## **Service Bulletin**

Bulletin No.: 21-NA-197

Subject: Power to the 110V/120 Outlet is Interrupted During an Auto Stop/Start Event (United

States ONLY)

5569856

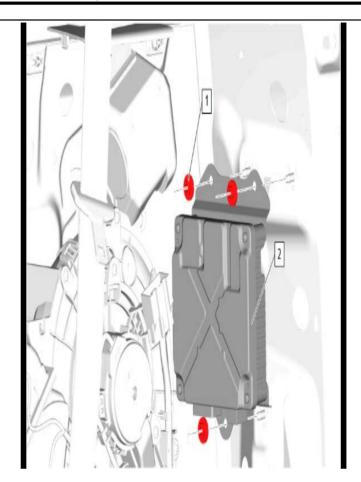
Replace the Accessory AC and DC Power Control Module (2). The new module has hardware and software modifications to maintain limited operation during Auto-Start events.

Refer to Accessory AC and DC Power Control Module Replacement, in SI.
